**BELL BEND NUCLEAR POWER PLANT  
IFIM AND AQUATIC IMPACT STUDIES WORKPLAN UPDATE  
BNP-2010-142 Docket No. 52-039**

As a result of field work completed from May 5-7, 2010, Section 6.3 (pages 49 – 51 of the original study plan) has been rewritten (See Enclosure 1). This includes an updated narrative summarizing the Bell Bend Project PHABSIM Transect Selection that occurred and a revised Figure 6.4 showing approximate location of each transect. Average daily measured flows during this timeframe were close to the high flow target of 10,000 cfs. The preliminary average daily measured flows were 10,100 cfs, 9729 cfs, and 8994 cfs. The corresponding provisional daily mean flows at the USGS Wilkes-Barre gage were 9190 cfs, 8860 cfs, and 8330 cfs.

Revised Section 6.3 of BNP-2010-103, "Study Plan to Assess the Potential Effects of the Bell Bend Project on Aquatic Resources and Downstream Users", dated April, 2010.

Figure 6-4.

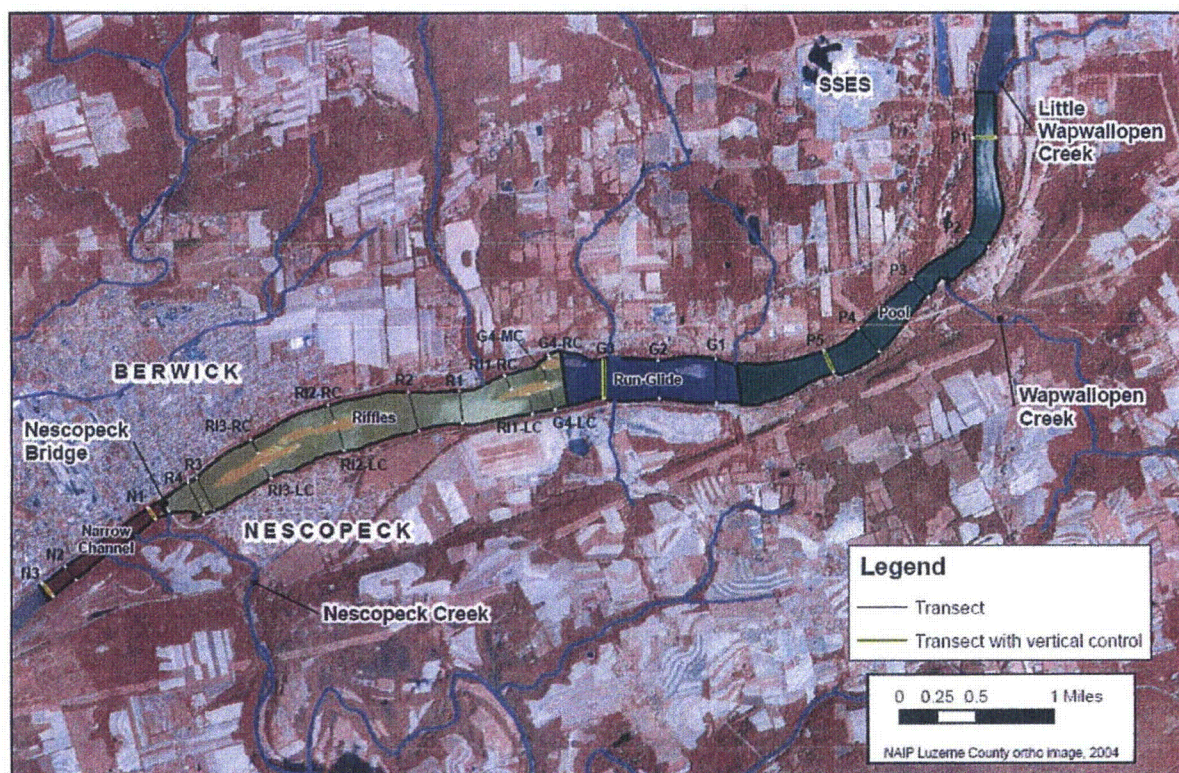
Actual transect placement took place between May 5 and 7, 2010 concurrent with high flow data collection. During transect placement the field crew first located the proposed transect endpoints using GPS. In most instances, transects were positioned as close as possible to the preliminarily selected locations. Five pool transects (P1 to P5) were selected to reflect variation in channel width and curvature. Four glide transects (G1 to G4) were placed within the "run/glide" habitat type, including one to represent the island and back channel at the lower end of that section. In Three riffle transects (R1 to R3) represent single-channel areas, again reflecting variation in stream width and depth, and another three (RI1 to RI3) were placed to represent the split-channel areas created by islands. A final three transects (N1 to N3) were selected to represent the "narrow channel" area downstream of Nescopeck Creek.

There were three exceptions during transect placement:

- 1) Pool P5 was moved upstream due to property and bank stabilization concerns along the left bank;
- 2) Glide G4 was intended to cross the tip of a mid-channel island and incorporate a small island near the right bank. Due to potential private property concerns the right channel portion of the transect was moved downstream. In addition, in order to maintain similar water surface elevations between channels, the remainder of the transect was also relocated, resulting in the inclusion of two islands and three channels. The final location of this transect is near the boundary of run/glide and riffle habitat, but based on observations at high flow the transect appears to incorporate both habitat types;
- 3) An additional riffle transect was added (R4) below a series of old bridge abutments to incorporate potential smallmouth bass spawning and rearing habitat.
